Bayside Planning Panel

Item No	6.1
Application Type	Section 96 Application – Commercial Development
Application Number	2001/537/16
Lodgement Date	9 May 2017
Property	238-262 and 240 Bunnerong Road, Hillsdale NSW Lot 102 DP 1072389
Owner	PO Sang Brothers Investment (Australia) Pty Ltd
Applicant	Milestone (AUST) Pty Ltd
Proposal	Section 96(2) Application to modify Development Consent No. 2001/537 to amend Condition No. 28 to permit the following hours for the southern loading dock: 7.00am to 8.00pm Monday to Saturday, and 8.00am to 8.00pm on Sunday and Public Holidays; and to amend Condition No. 27 to refer to an amended loading dock plan of management for the Aldi Store.
No. of Submissions	Thirteen (13) submissions – first round of notification (2 June to 16 June 2017) Four (4) submissions – second round of notification (3 November to 17 November 2017)
Cost of Development	\$0
Report by	Olivia Yana, Acting Senior Development Assessment Planner

Planning Assessment Report

Application Number:	2001/537/16
Date of Receipt:	9 May 2017
Property:	238-262 and 240 Bunnerong Road, Hillsdale NSW Lot 102 DP 1072389
Owners:	PO Sang Brothers Investment (Australia) Pty Ltd
Applicant:	Milestone (A

Figure 1 – Site Plan

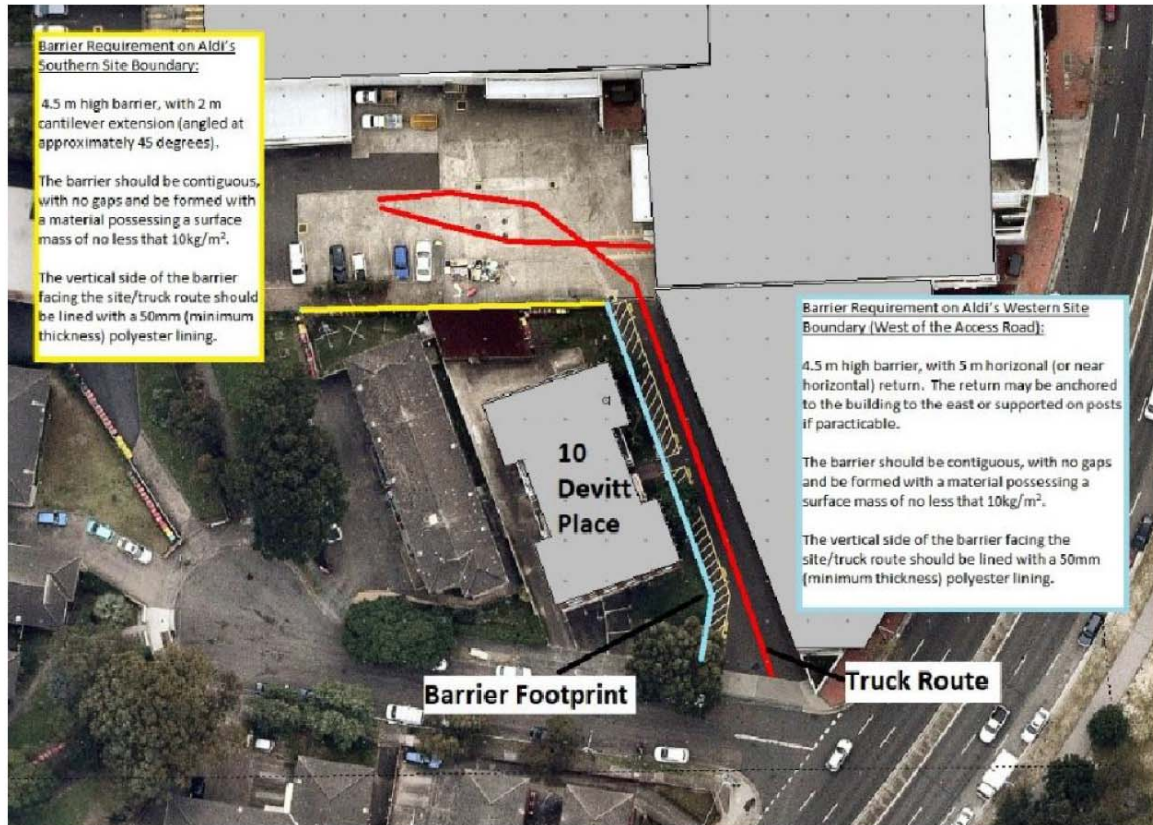
To ensure compliance with the 49dBA criterion at all floors of the apartment building, it would require the following measures (refer to Figure 1).

- a) A 4.5 metre barrier near the boundary along the length of the access lane with a 5 metre horizontal section (roof) partly over the lane. The 5 metre horizontal section could be supported on a structure which could extend across the lane and may be fixed to the existing shopping centre building (refer to Figure 2); and
- b) A 4.5 metre noise barrier on the boundary between the dock and the apartments with a 2 metre cantilevered section extending out over the dock turning area at 45 degrees (refer to Figure 3).

Figure 4 – Location of Southern Loading Dock Users

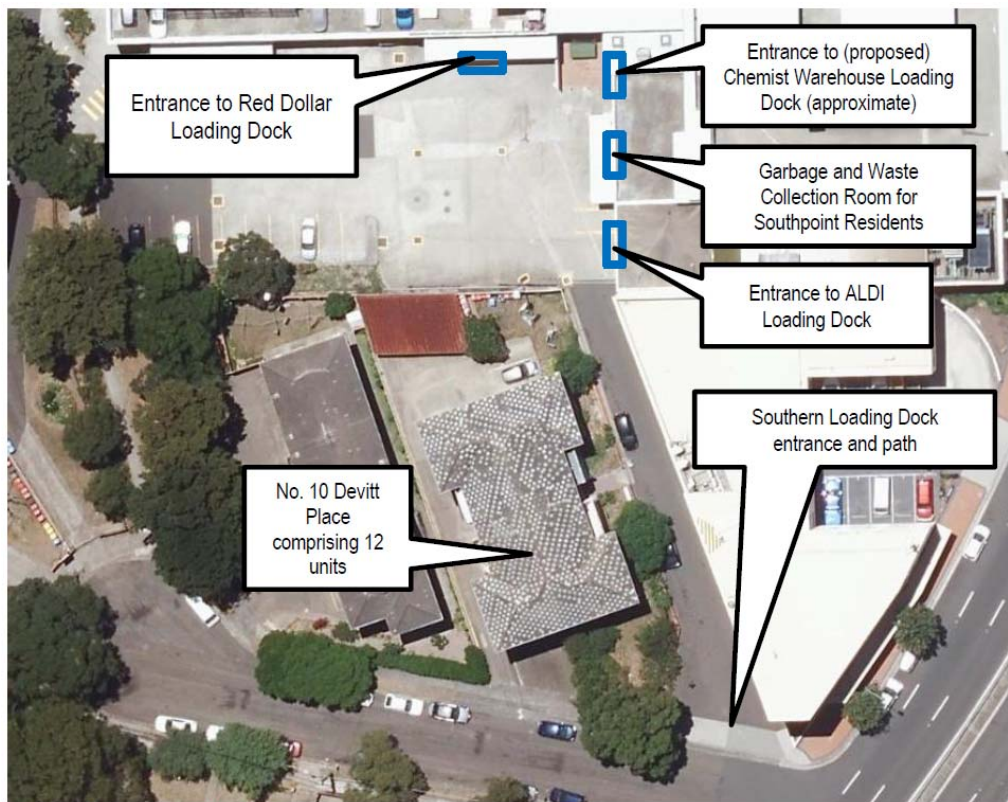
The users of the southern loading dock, excluding Aldi, are as the following (refer to Figure 4).

The Southern Loading Dock Management Plan states the following to ensure adverse noise impacts are minimised.

- The use of the extended southern loading dock delivery hours are for the exclusive use of ALDI Stores only. The ALDI Loading Dock is clearly signposted. All other users of the Loading Dock will continue to operate under the existing Loading Dock operating hours;
- Southpoint Shopping Centre Security will continue to monitor the loading dock after delivery hours to ensure no deliveries are being made outside of the approved hours;
- Southpoint Shopping Centre Security will ensure no deliveries are being made within the extended delivery hours by other users of the Southern Loading Dock;

- The gate which separates the Southern Loading Dock will be locked at 8.00pm Monday to Saturday and at 8.00pm on Sunday by Southpoint Shopping Centre to ensure no deliveries are made after the approved extended hours.

Figure 1 – Site Plan

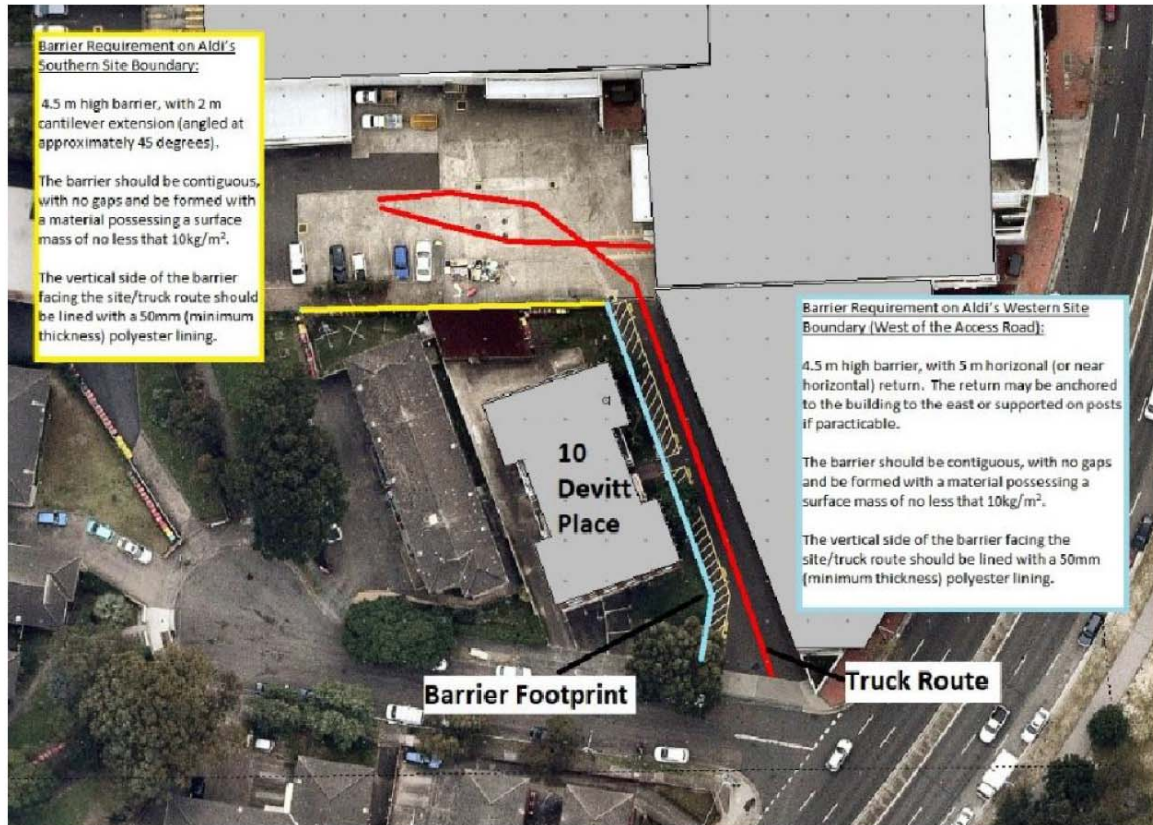
To ensure compliance with the 49dBA criterion at all floors of the apartment building, it would require the following measures (refer to Figure 1).

- a) A 4.5 metre barrier near the boundary along the length of the access lane with a 5 metre horizontal section (roof) partly over the lane. The 5 metre horizontal section could be supported on a structure which could extend across the lane and may be fixed to the existing shopping centre building (refer to Figure 2); and
- b) A 4.5 metre noise barrier on the boundary between the dock and the apartments with a 2 metre cantilevered section extending out over the dock turning area at 45 degrees (refer to Figure 3).

Figure 4 – Location of Southern Loading Dock Users

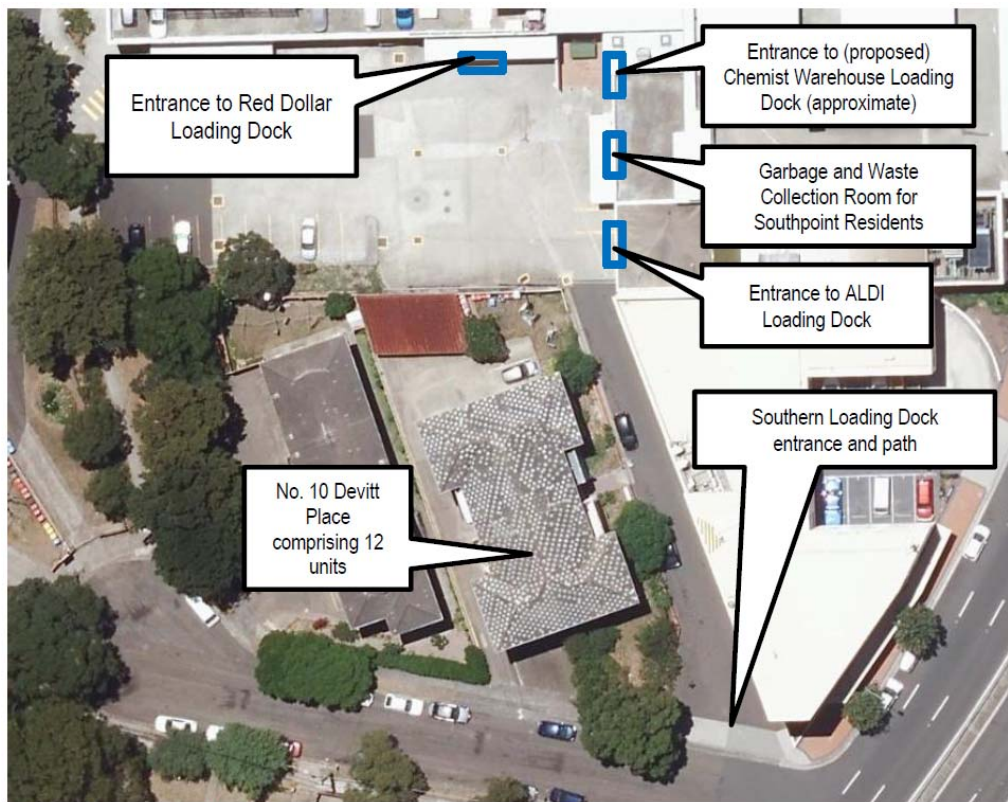
The users of the southern loading dock, excluding Aldi, are as the following (refer to Figure 4).

The Southern Loading Dock Management Plan states the following to ensure adverse noise impacts are minimised.

- The use of the extended southern loading dock delivery hours are for the exclusive use of ALDI Stores only. The ALDI Loading Dock is clearly signposted. All other users of the Loading Dock will continue to operate under the existing Loading Dock operating hours;
- Southpoint Shopping Centre Security will continue to monitor the loading dock after delivery hours to ensure no deliveries are being made outside of the approved hours;
- Southpoint Shopping Centre Security will ensure no deliveries are being made within the extended delivery hours by other users of the Southern Loading Dock;

- The gate which separates the Southern Loading Dock will be locked at 8.00pm Monday to Saturday and at 8.00pm on Sunday by Southpoint Shopping Centre to ensure no deliveries are made after the approved extended hours.
